Model	SS930/950/915, Ges5130/5170/5210, Rex1060/1070/1140	Volt/Hz	Date of Modification	Serial Number
Modified Article	Upper Master Feed Roller & Upper Reverse Roller			
Reason for Modification	To increase the master paper feeding ability

DETAILS OF MODIFICATION

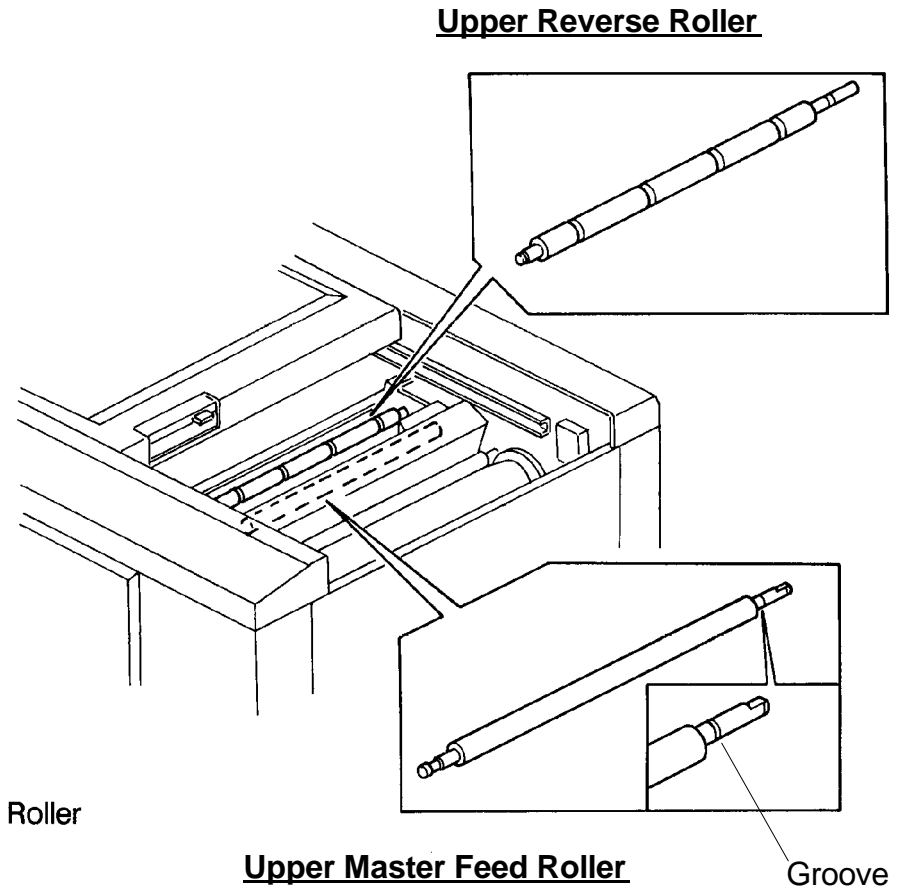
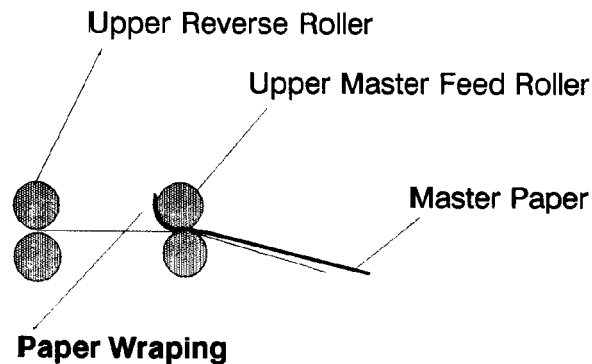
If the machine is used under extremely low humidity and temperature conditions, master paper may be wrapped around the upper master feed roller or upper reverse roller when master paper is feeding. This symptom is due to heavy static in such circumstances.

To increase the master paper feeding ability even under such circumstances, the upper master feed roller has been changed to an electrically conductive type. Also, the upper reverse roller has been changed to an anti-static type.

- NOTE: * The color of the upper reverse roller has been changed from gray to pink.
* The shaft of the new upper master feed roller has a groove for identification. (However, some of the first production rollers do not have the groove. They can be distinguished by the part number.)

FLAT CABLE POSITION

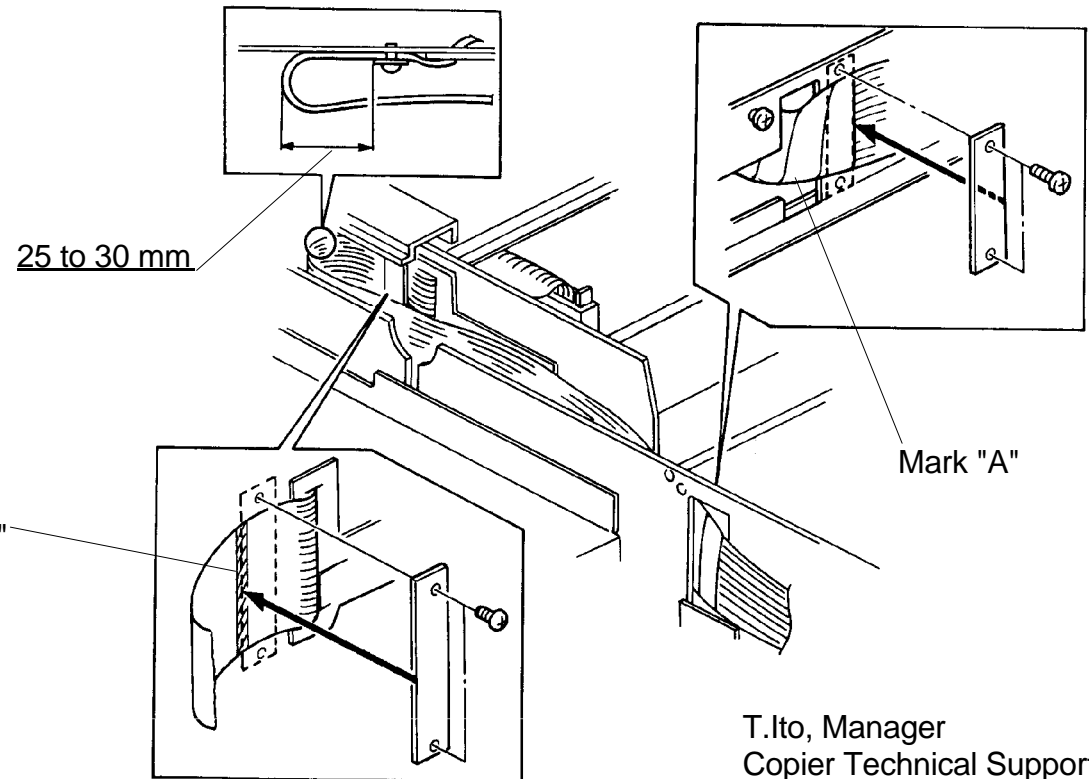
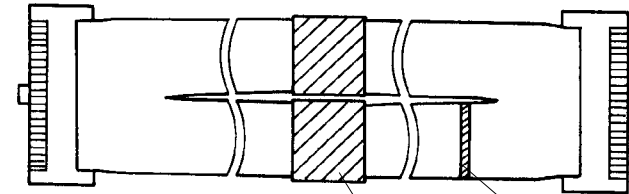
To facilitate assembly on the production line, marks ("A" and "B") have been added to the flat cable between the machine frame and scanner unit. On the production line the flat cable is assembled as shown in the illustration.

If the flat cable is not correctly installed, it may be distorted or crimped when the scanner unit is open. (To prevent the flat cable from being damaged by the edge of the frame, a strip of tape (Mark "A") has been added to the flat cable.) The flat cable is correctly positioned as shown in "FLAT CABLE POSITION" when the scanner unit is open.

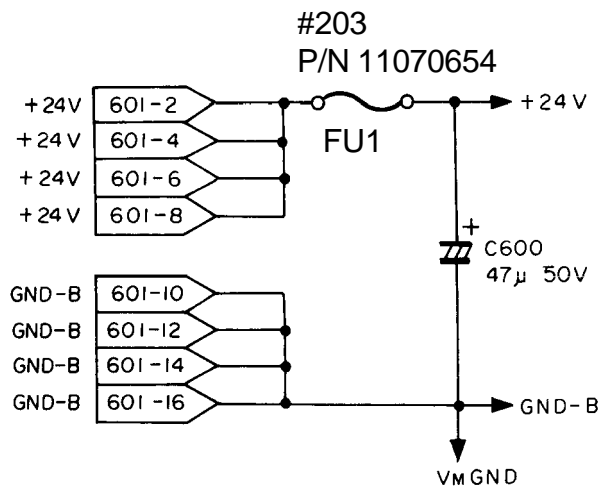
To ensure reliability of A/D conversion board, the fuse1 (P/N11070654) has been added to the main control board. And two capacitor (C609, C713) have been removed from the main control board.

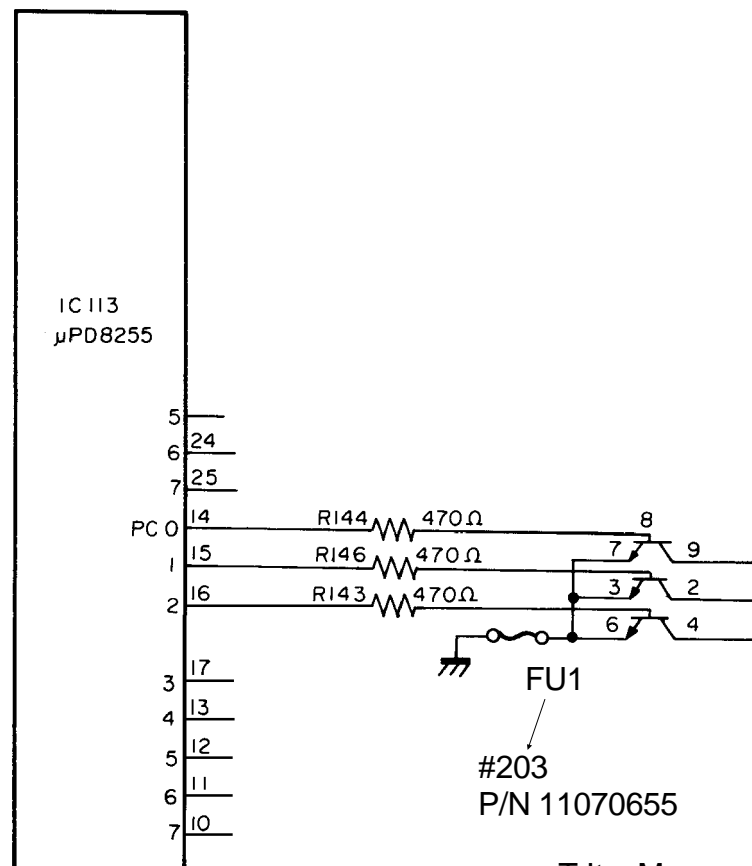
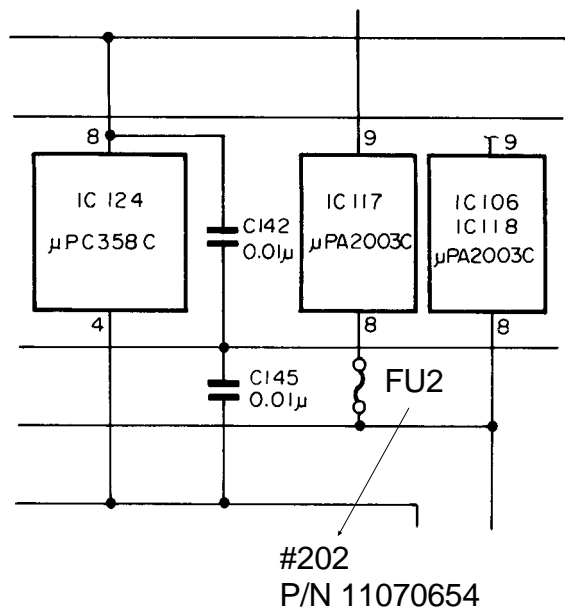
It has been reported that IC113 and IC117 were sometimes damaged due to excessive current. To ensure the reliability and durability of the main control board, the following parts have been added to the main control board.

- FU1 Newly added P/N 11070655, Index No.203
- FU2 Newly added P/N 11070654, Index No.202

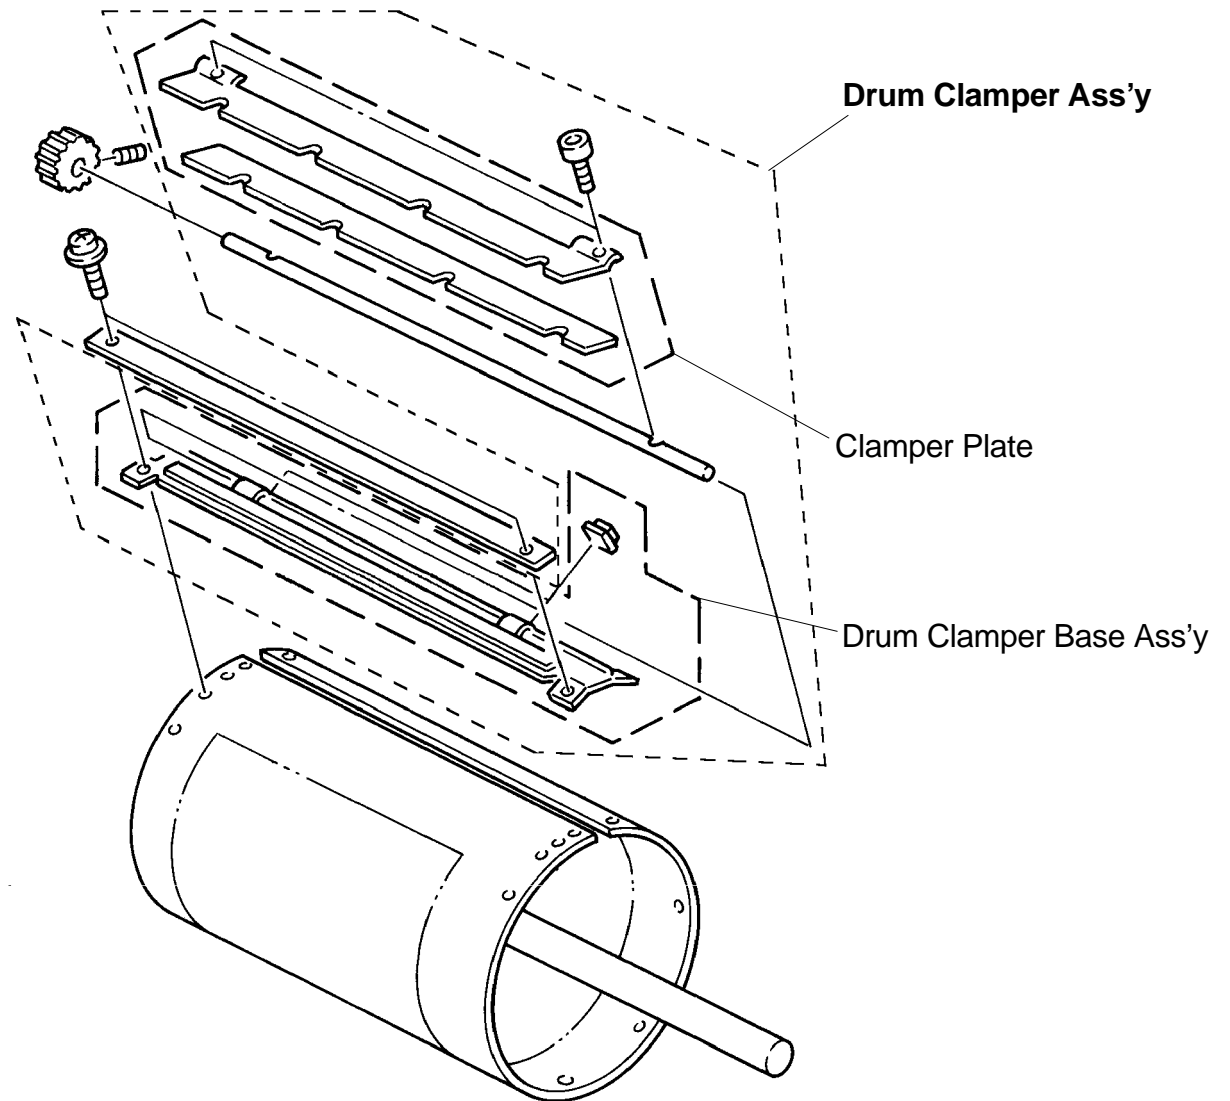
To facilitate servicing, the drum clamber ass'y has been registered as a service part. Use this assembled part when the old type clamber plate and/or drum clamber base ass'y are replaced.

NOTE: The difference between the drum clamber ass'y #C2034565 (for models C201, C203, C204, and C206) and #C2074948 (for models C205, C207, and C208) is the color of the base plate of the drum clamber base ass'y only. The base plate's color of #C2074948 is black to ensure the drum master detection sensor function.

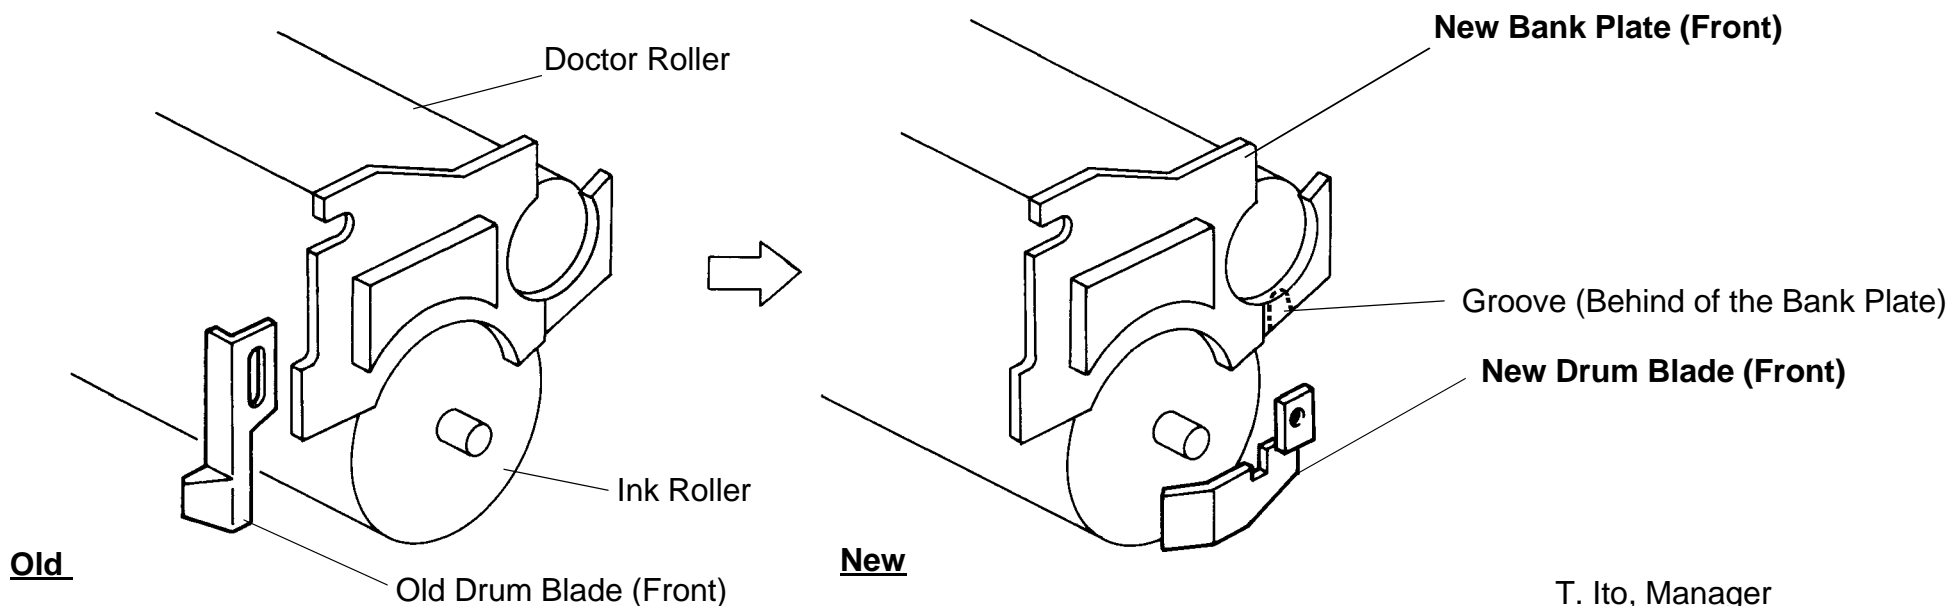
Especially when the print volume is large, ink builds-up on the ink roller edges and may transfer to inside of the drum screen and leak from the drum edges. To prevent this, the following modifications have been implemented:

1. To scrape off the built-up ink on the ink roller edges, the front and rear drum blades have been changed as shown below. (The old type drum blades scraped the inside of the drum screen.)
2. To prevent built-up ink on the ink roller edges from being scraped off by the edge of the bank plates and falling on the inside of the drum screen, a groove has been hollowed out at the edge of the front and rear bank plates.
3. To allow installation of the new drum blades, a hole has been added to the front and rear side plates of the ink roller unit (Front/Rear Side Plate - Ink Roller: Not shown in illustration).

[Old]**[New]**

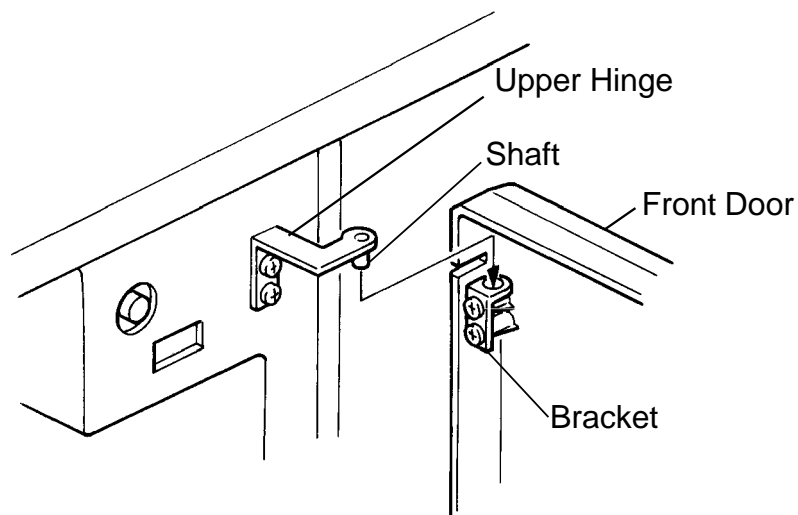
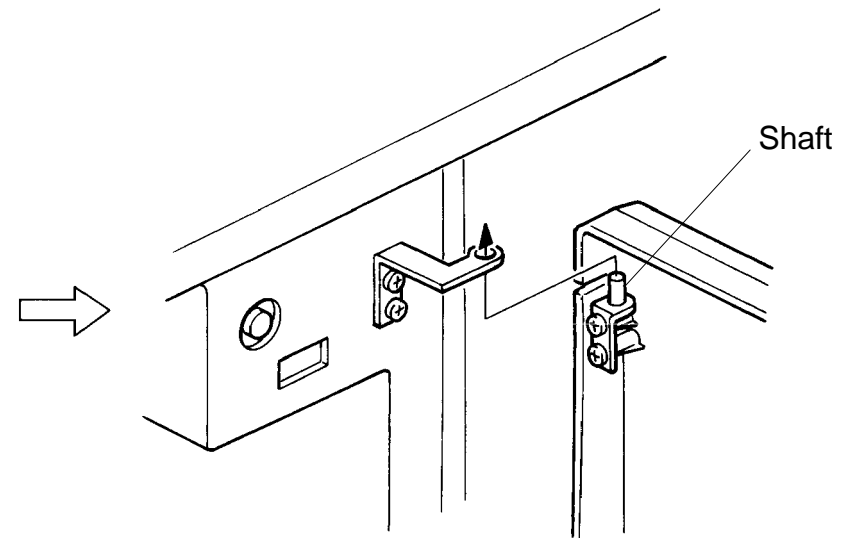
To improve durability of the front door hinges, the upper and lower hinges and the hinge brackets have been changed.

If the hinges are bent by being opened and closed roughly, the front door may get unhinged. The shaft in the hinges has been lengthened from 2.5mm to 5.9mm to prevent this. However, the shaft, which was installed in the hinges (main body side) in the old type, is now being installed in the hinge brackets (front cover side) as shown below. Therefore, there is interchangeability only as a set of the upper and lower hinges and the two brackets.

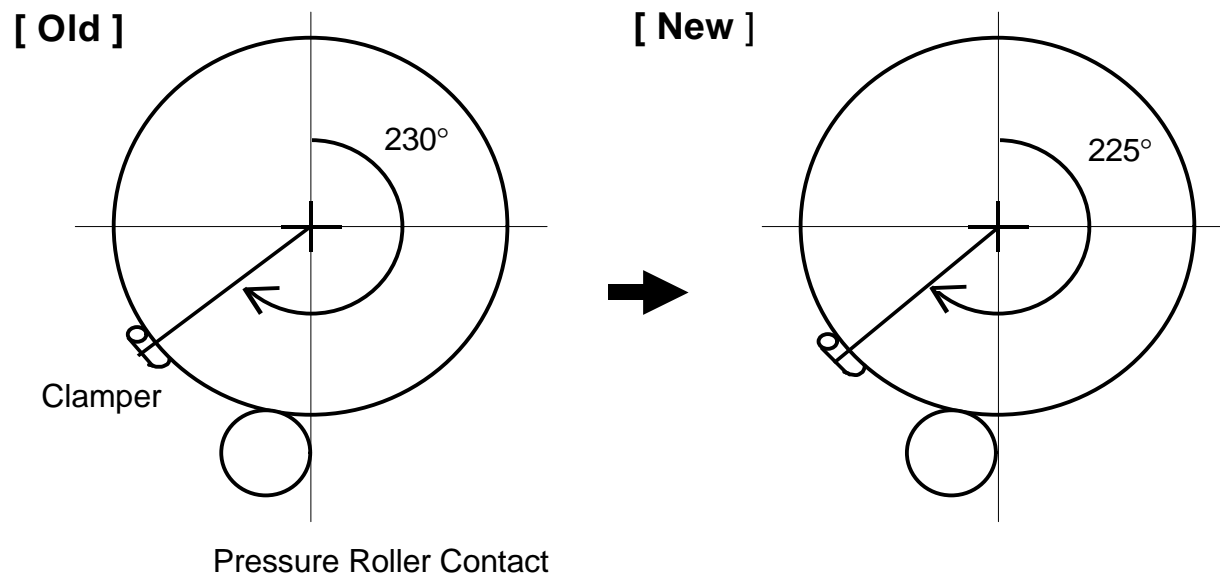
To ensure the printing quality on the leading part of the paper, the shape of the print pressure cam has been changed. If there is solid fill image on the leading part of the original and the printing speed is high (4 or 5 step), a low density horizontal band may appear about 30 millimeters from the leading edge of the print. This is caused by pressure roller bound when the pressure roller contacts the drum surface. The new print pressure cam applies the print pressure to the pressure roller 5 degrees faster in the drum rotation angle. (The pressure roller contacts the drum about 7 millimeters before the leading edge of the paper.)

NOTE: When the new print pressure cam is installed, the exit pawl timing is also changed. (The exit pawl approaches the drum 5 degrees faster in the drum rotation angle.) Therefore, it is necessary to make sure that the exit pawl does not contact the master clamper. (Readjust the exit pawl timing if necessary.)

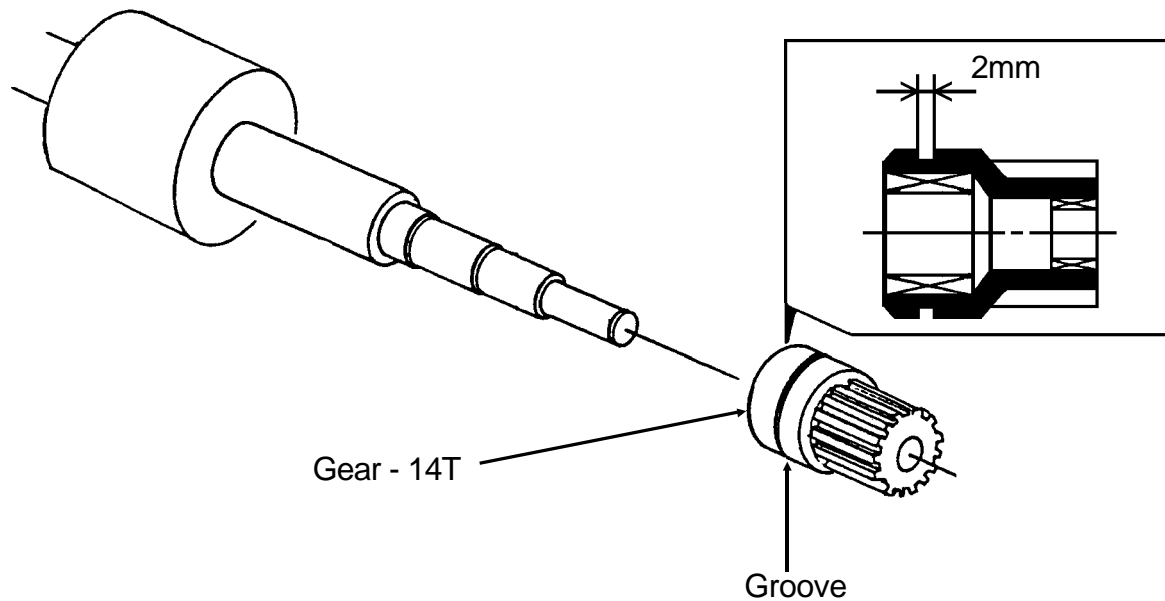
It was reported that on some machines in the field, the image position varies. Although this is a very rare case, at worst this happened after making about 200,000 prints. On the problem machine, the one-way clutch inside the 2nd feed roller gear slips just when the 2nd feed rollers start feeding a sheet. (The paper feed start timing is delayed.) This makes the image position vary, i.e. move up or down in paper feed direction. After investigation, it was found that the grease inside the one-way clutch changes in quality and damage the inside surface of the clutch. The new 2nd feed roller gear contains a new type of grease that does not change in quality unlike the old one. To distinguish the new gear from the old one, a groove is made on the new gear.

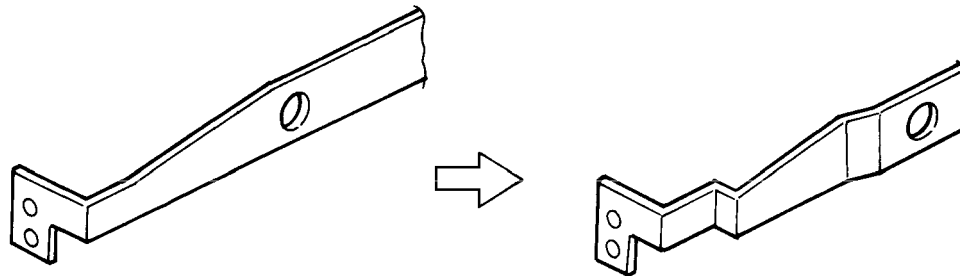
When the paper table is lowered, the feed roller arm contacts the side pad lever if the paper feed side plates are fully opened. To prevent this, the shape of the feed roller arm has been changed as shown in the illustration below.

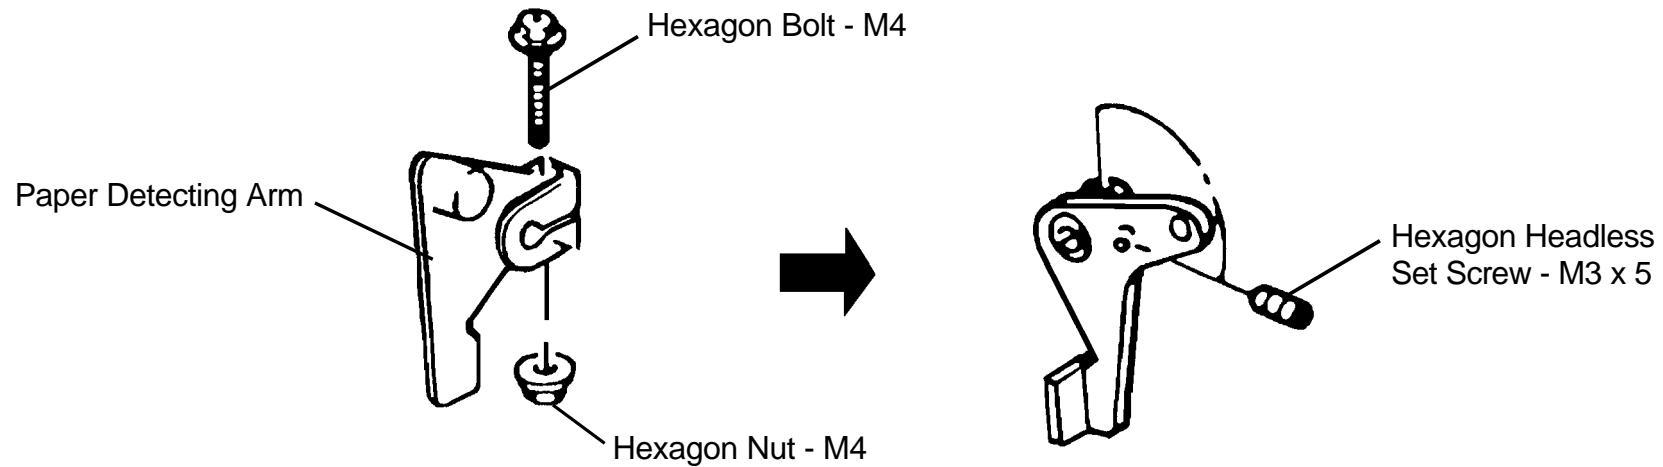
To improve strength and durability, the paper detecting arm has been changed to the type used on the NA2 (C210).
